UNITED STATES
NUCLEAR REGULATORY COMMISSION
WASHINGTON, D. C. 20555

FACILITY: Oyster Creek Nuclear Generating Station

SUBJECT: JANUARY 23, 1986, MEETING WITH GPU NUCLEAR CORPORATION (GPUN) TO
DISCUSS THE CHANNEL CHECKS FOR OPERABILITY OF THE LOW AND LOW-LOW
REACTOR WATER LEVEL INSTRUMENTATION CHANNELS

SIMPLIFIED SCHEMATIC OF THE LOW AND LOW-LOW REACTOR WATER LEVEL
INSTRUMENTATION CHANNEL SWITCHES

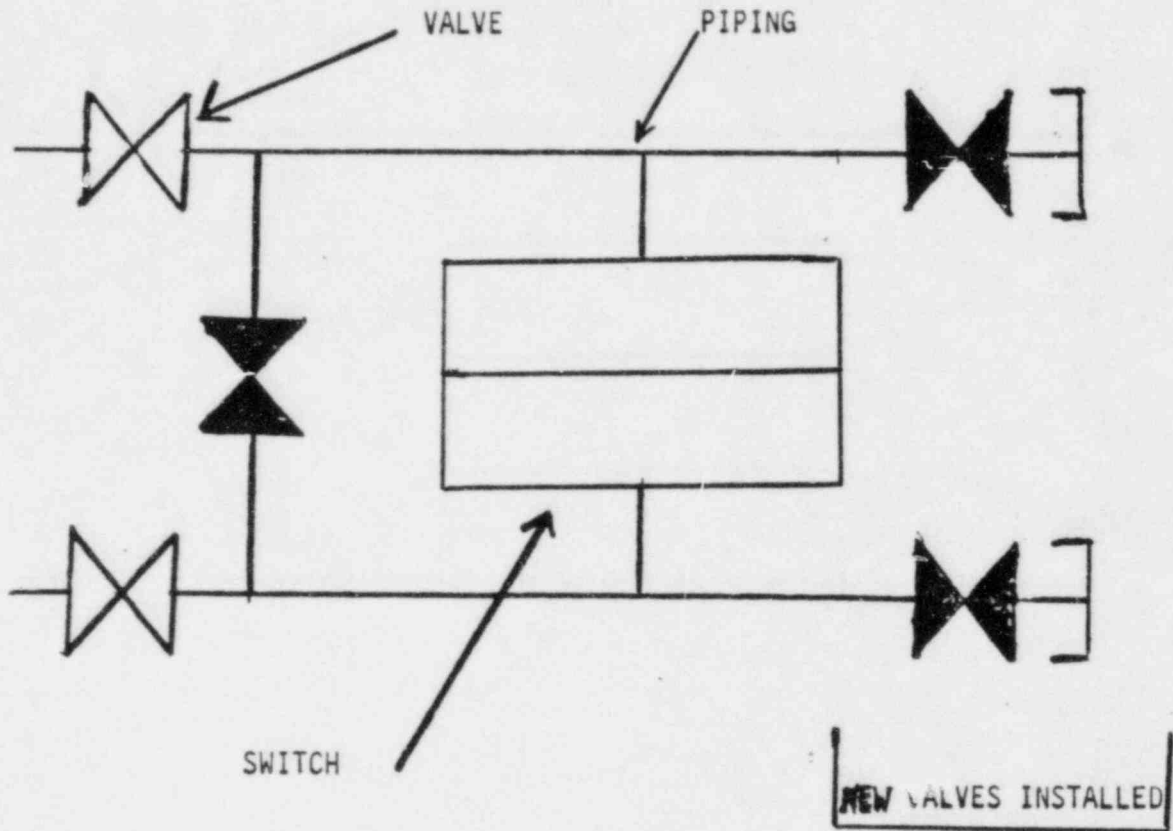
was to (1) open the isolation valve between the switch and the upper part of the reactor vessel (reference leg) which results in an indication in the control room of the reactor water level being less than low and low-low water level setpoints and (2) open the isolation valve between the switch and the lower part of the reactor vessel (measurement leg) which clears the above indication. This will be referred to as the communication test or C-test.

On Friday, January 17, 1986, normal surveillance was conducted on the low reactor water level instrumentation channel switches. The setpoint for three of these switches was found to be outside the acceptance criteria. The switches were recalibrated, verified to be in communication with the reactor vessel using the C-test described above and returned to service. Two of these three switches were again surveilled on Monday, January 21, 1986, and the drift in the setpoints were found to be insignificant, however, one switch would not reset during the C-test. The licensee declared this switch inoperable and decided to replace the switch.

The licensee stated that the C-test may have contributed to the failure of the switch to reset. The switch manufacturer had stated to the licensee that the C-test would cause a shift in the setpoint in the conservative direction but this would be temporary and the setpoint would return to its calibrated value. The licensee, however, has also decided to modify the C-test. On only the switch that was replaced, two additional valves, as shown in the figure on the next page, were added so that the pressure in the switch can be measured by a pressure gauge which is attached to either of the new valves. By properly opening and closing the isolation valves, the pressure measured by the gauge would indicate that the switch was in proper communication with the reactor vessel. The new method was explained to the staff by the licensee and accepted by the staff.

The licensee does not believe the problem with the one switch above is generic to the remaining seven switches. The licensee is now planning to install the new valves on the remaining switches as surveillance is required on these switches by the Technical Specifications and return all the switches to service using the modified C-test as described above.
